PRODUCT CHANGE NOTIFICATION (PCN)

AMJG0808-0300-BKB-26 MODULAR CABLE

CHANGE NOTIFICATION:	PCN 20220425_AMJG0808-0300-BKB-26
DESCRIPTION OF CHANGES:	CHANGE OF DATA SHEET CHANGE OF DATA SHEET New Draw.-No. ASS_7947_CArev02
REASON FOR CHANGE:	CHANGE OF PRODUCT LOCATION CHANGE OF PRODUCT LOCATION
KEY CHARACTERISTICS OF CHANGE:	Details see page 3
PRODUCTS AFFECTED:	AMJG0808-0300-BKB-26
DATE OF CHANGE AND IMPLEMENTATION:	CHANGE: WEEK 18 / YEAR 2022 IMPLEMENTATION: 25/4/2022
RESPONSE:	NO RESPONSE TO THIS NOTIFICATION IS REQUIRED

DK-1611-025/G MODULAR CABLE

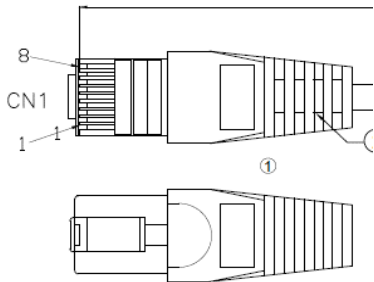
CHANGE OF DATA SHEET
CHANGE OF DATA SHEET
New Draw.-No. ASS_7510_CArev01

CHANGE OF PRODUCT LOCATION
CHANGE OF PRODUCT LOCATION

DK-1611-010/BL MODULAR CABLE

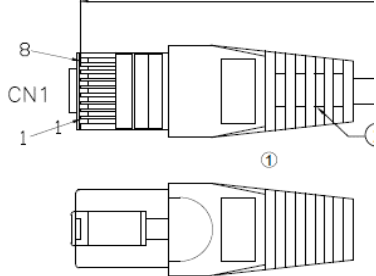
CHANGE OF DATA SHEET
CHANGE OF DATA SHEET
New Draw.-No. ASS_7510_CArev01

CHANGE OF PRODUCT LOCATION
CHANGE OF PRODUCT LOCATION

DK-1511-005/G MODULAR CABLE

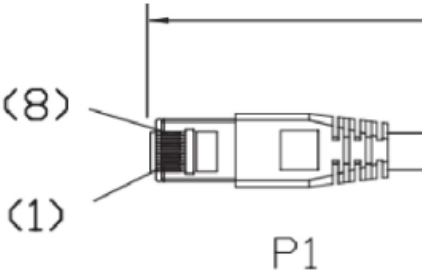
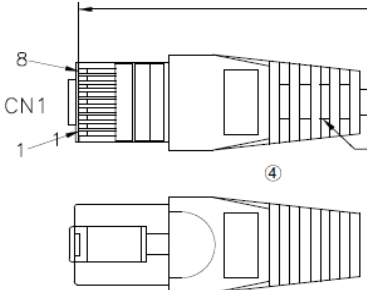
CHANGE OF DATA SHEET
CHANGE OF DATA SHEET
New Draw.-No. ASS_7160_CArev04

CHANGE OF PRODUCT LOCATION
CHANGE OF PRODUCT LOCATION

DK-1511-003/B MODULAR CABLE

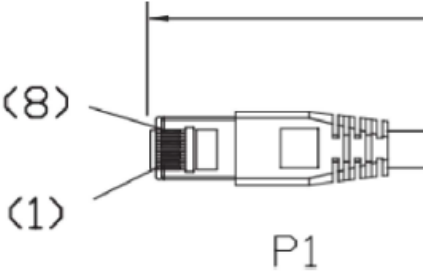
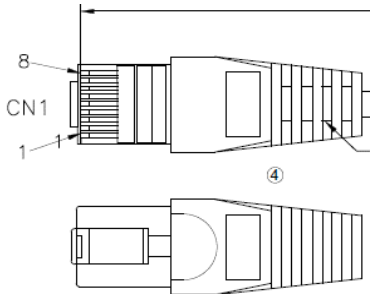
CHANGE NOTIFICATION:	PCN 20220425_DK-1511-003/B
DESCRIPTION OF CHANGES:	CHANGE OF DATA SHEET CHANGE OF DATA SHEET New Draw.-No. ASS_7160_CArev04
REASON FOR CHANGE:	CHANGE OF PRODUCT LOCATION CHANGE OF PRODUCT LOCATION
KEY CHARACTERISTICS OF CHANGE:	Details see page 3
PRODUCTS AFFECTED:	DK-1511-003/B
DATE OF CHANGE AND IMPLEMENTATION:	CHANGE: WEEK 18 / YEAR 2022 IMPLEMENTATION: 25/4/2022
RESPONSE:	NO RESPONSE TO THIS NOTIFICATION IS REQUIRED

DK-1511-001/BL MODULAR CABLE

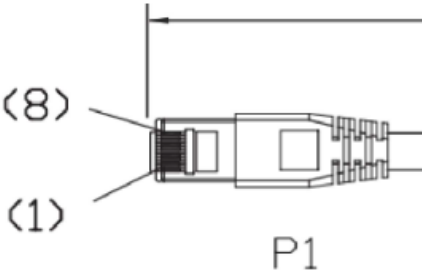
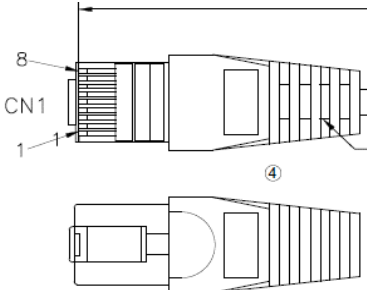
CHANGE OF DATA SHEET
CHANGE OF DATA SHEET
New Draw.-No. ASS_7160_CArev04

CHANGE OF PRODUCT LOCATION
CHANGE OF PRODUCT LOCATION

DK-1511-025/G MODULAR CABLE

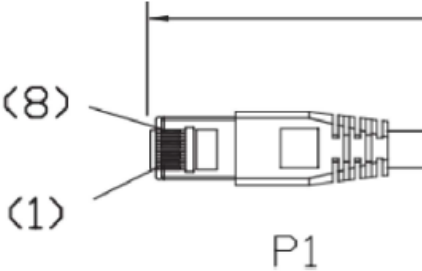
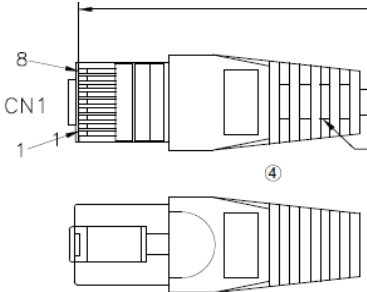
CHANGE OF DATA SHEET
CHANGE OF DATA SHEET
New Draw.-No. ASS_7160_CArev04

CHANGE OF PRODUCT LOCATION
CHANGE OF PRODUCT LOCATION
